GLEN LEONARD DAM
JEFFERSON COUNTY, MISSOURI

PHASE I INSPECTION REPORT
NATIONAL DAM SAFETY PROGRAM

PREPARED BY: ST. LOUIS DISTRICT CORPS OF ENGINEERS
FOR: GOVERNOR OF MISSOURI

SEPTEMBER 1978

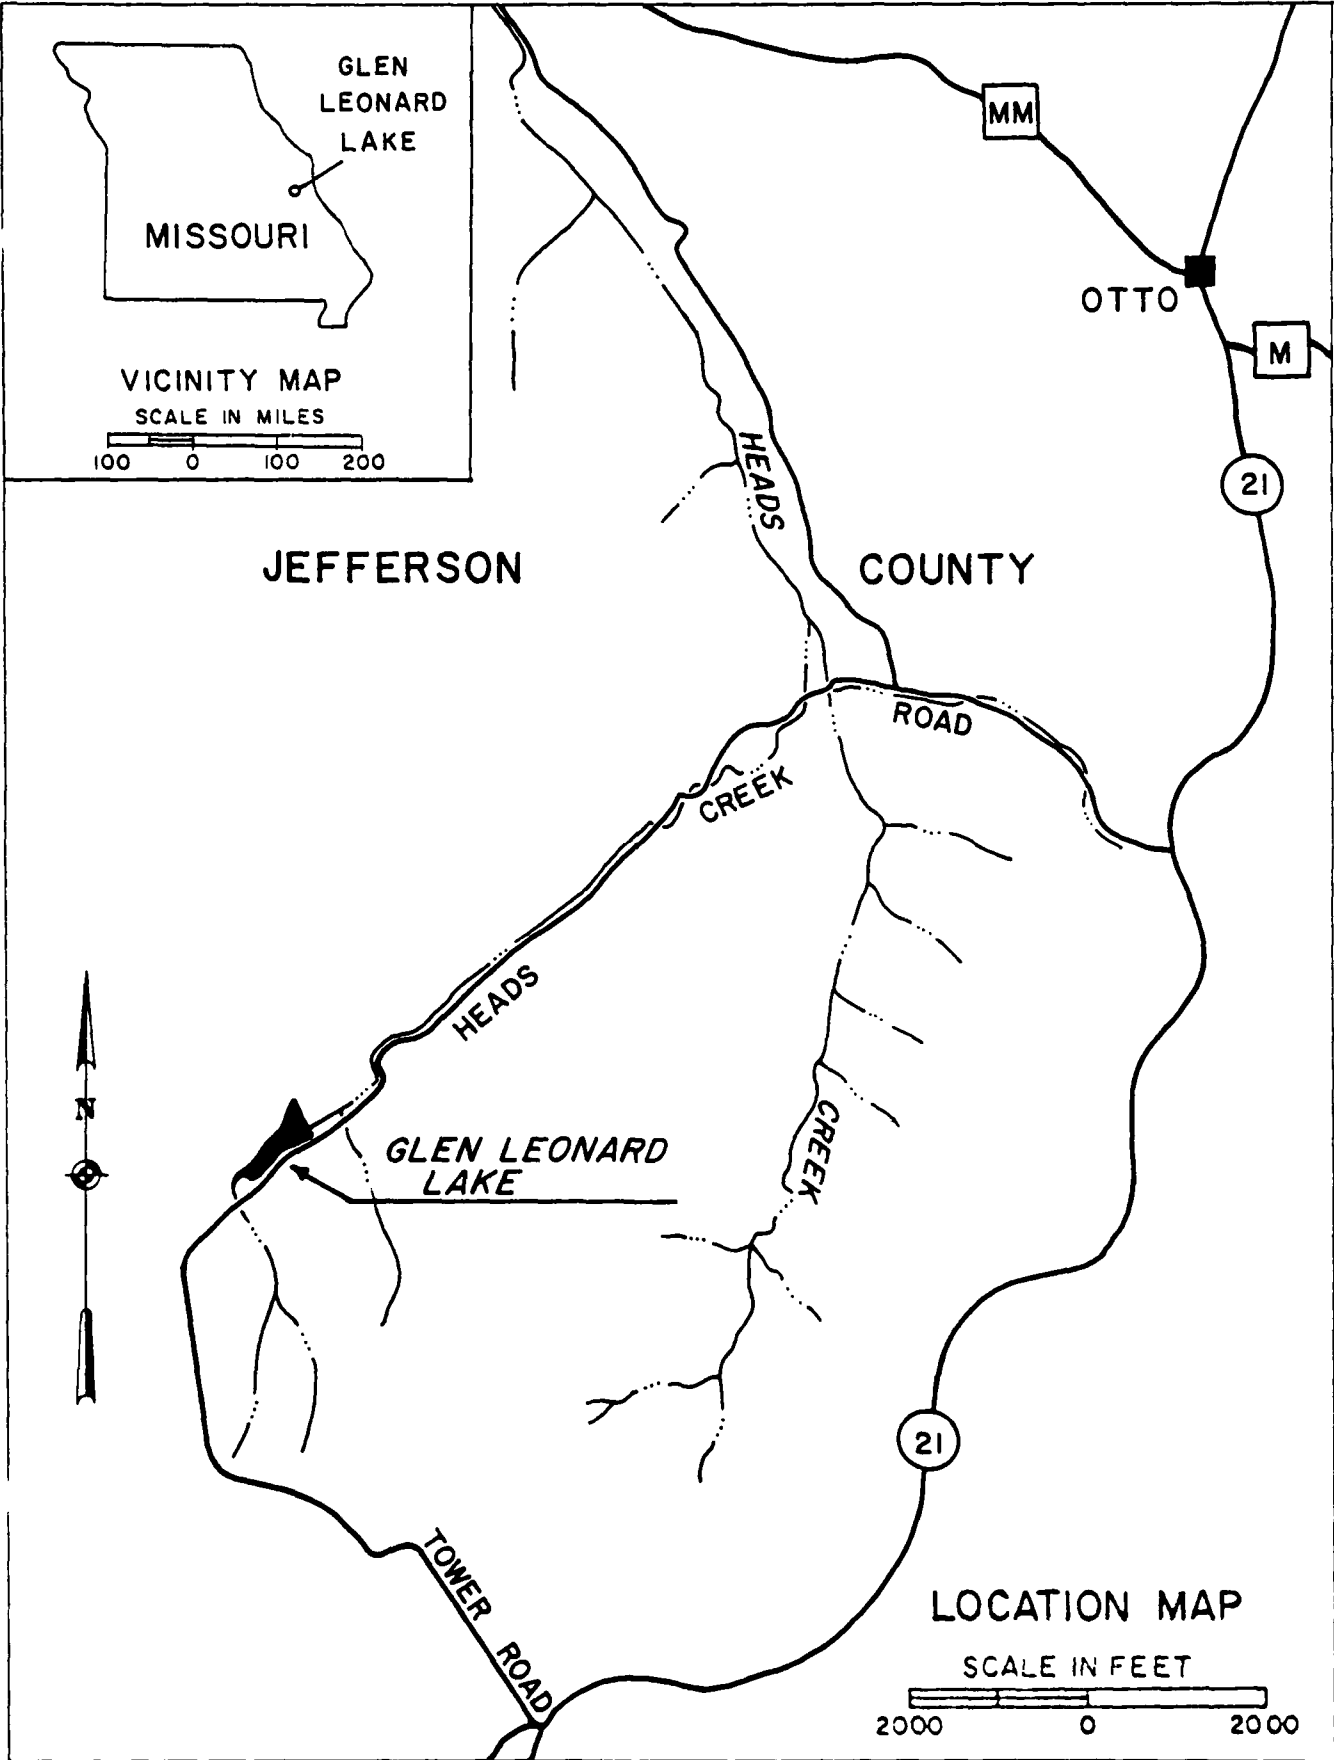
(2) Level the dam crest along the waterline traverse and in the small ditch traverse to the dam axis at approximately station 0+25 as shown on PLATE 3 and establish a grass cover.

PLATE 2

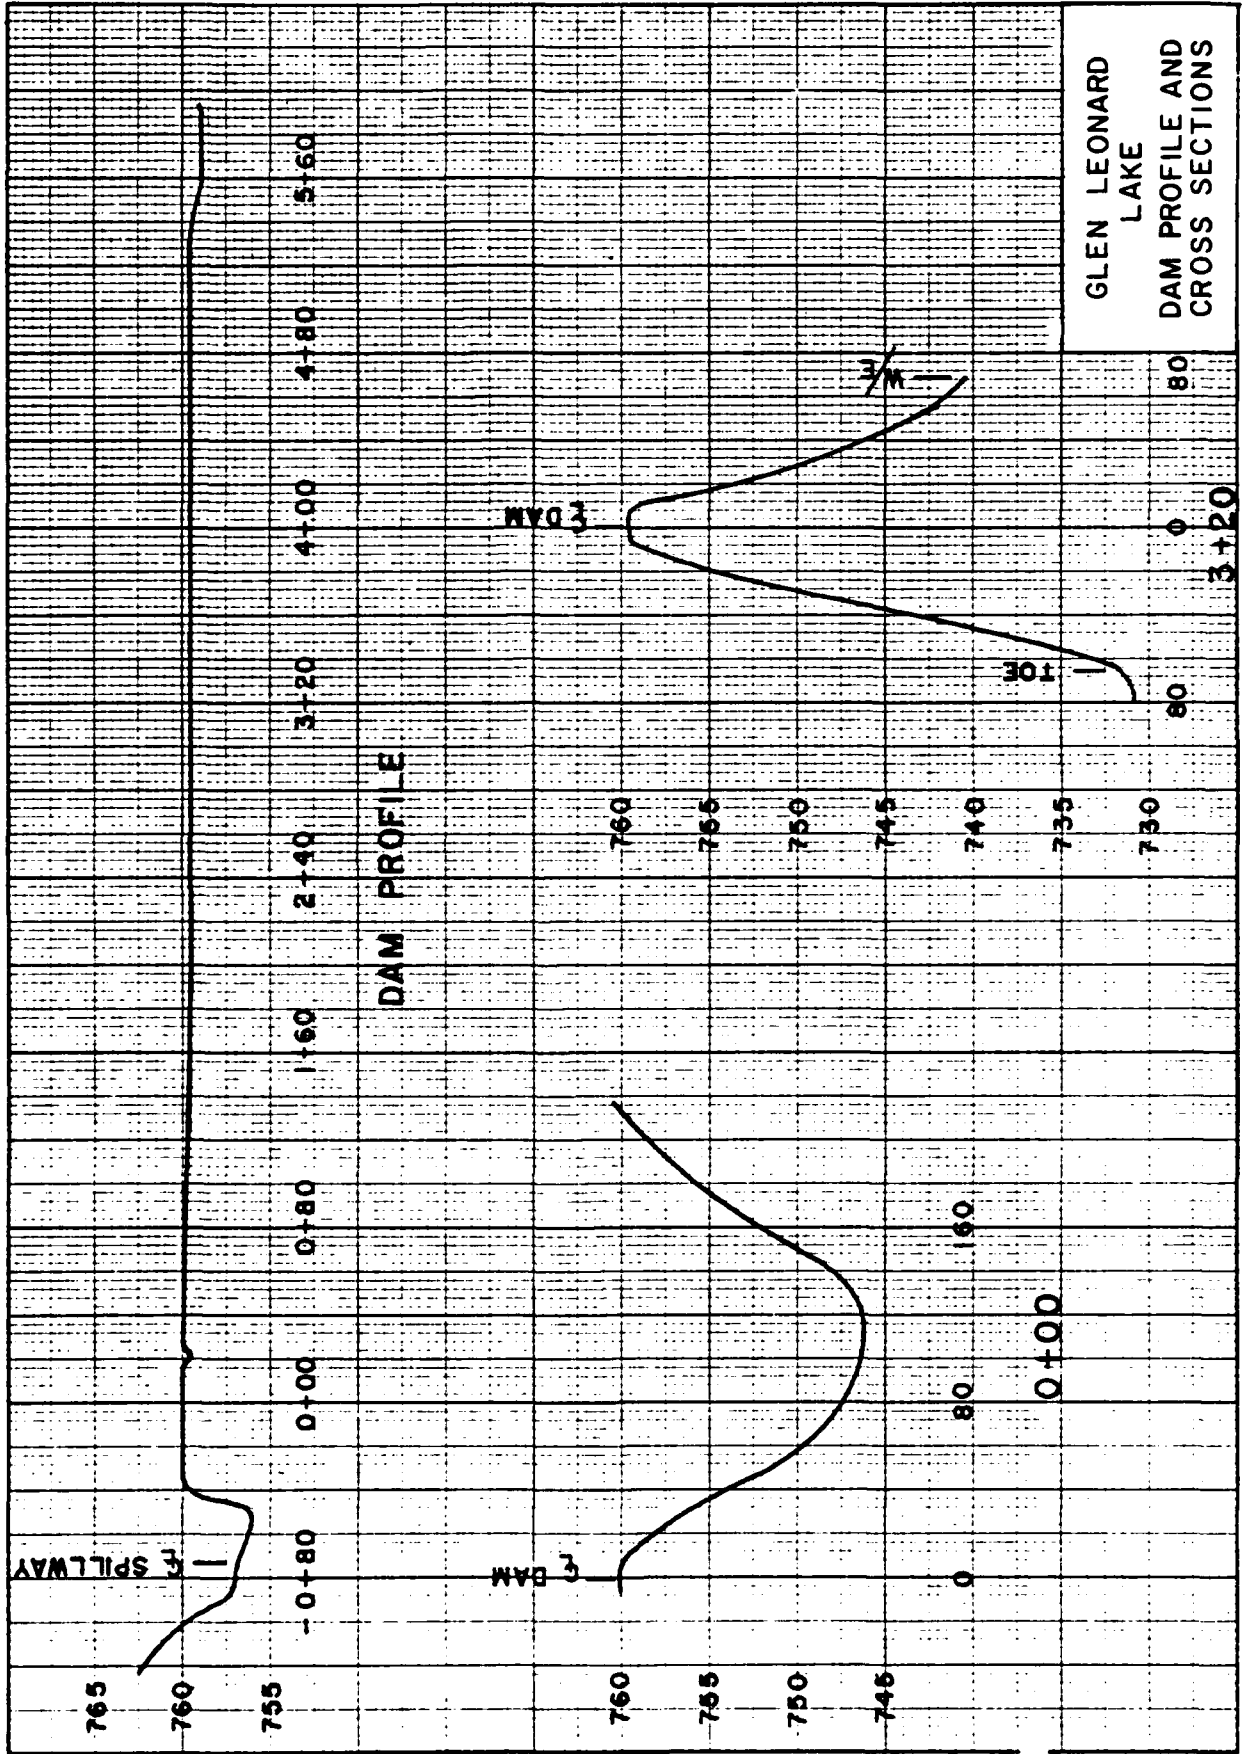
(1) The dam is an earth structure built in a small valley in the north-east portion of the Missouri Ozark Region. Topography adjacent to the lake is rolling. Topography in the vicinity of the dam is shown on PLATE 2.

b. Location. The dam is located in the north-east portion of Jefferson County, Missouri, just southwest of Otto, Missouri. The lake formed by the dam is shown on the 1974 revised Belew Creek, Missouri USGS Quadrangle Sheet in the southeast quarter of Section 26, Township 42N, Range 4E (see PLATES 1 and 2).
